Sinking of a well at Bhavikere in the Tarikere taluk.

Grant of a further sum of Rs 317 from L.F. General for sinking a well at Bhavikere in the Tarikere Taluk.

Revised Estimate for sinking a circular drawing well at Bhavikere in the Tarikere Taluk.

లక్కువళి శిలాబళి మోజే భావికేరి గ్రామదభావికేలసానడదబత్రే ప్లాన్.

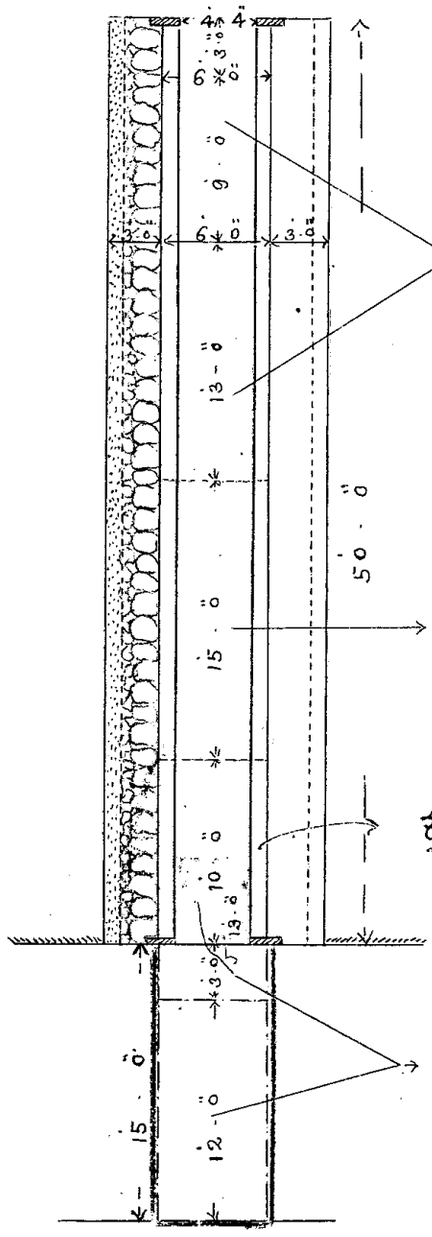
బిల్లనంబర 1 నేదరల్ల ఇకేలసానడద్దు

బిల్లనంబర 2 నేదరల్ల ఇకేలసానడద్దు

కనత్తు కేరాంతు బిల్లువ భాగవు

బిల్లనంబరు 3-4 రల్ల కేలసానడద్దు. ఆందరే పున: ఆజమాఇతిమా దువల్ల 15 ఆడిప్రాలా తవావలకండబందద రిందాఱ్ఱిందా సవల మేంటె ఆందాళాదల్లదాంతు బిల్లనంబర 5 నేదరల్లవజా మాడిరుత్తే.
